MEMORANDUM

To: Development Review Board
From: Mary O'Neil, AICP, Principal Planner
Date: July 14, 2020
RE: ZP20-0667CA 188 (-192) South Champlain Street

Request: Convert single family home to six units. Expand parking. Request for a 4 space, 40% parking waiver.

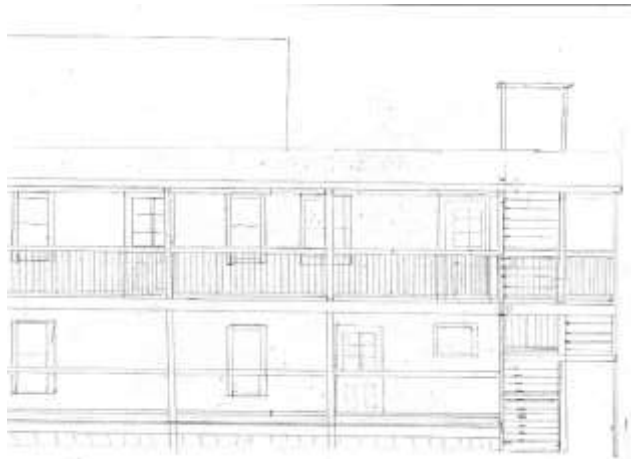
As noted, the DAB recommended redesign of the deck as a two-story porch. The results of that effort are seen below.

The introduction of three new doors are modestly arranged within existing building openings on secondary elevations. Care must be exercised that the concatenation of discrete alterations (window replacement, new decks and walkways, modern doors, expansion of paving) does not collectively alter the historic character of the home. The reduction in paving for parking, and the effort to redesign the access porch contribute to ameliorate those cumulative changes.
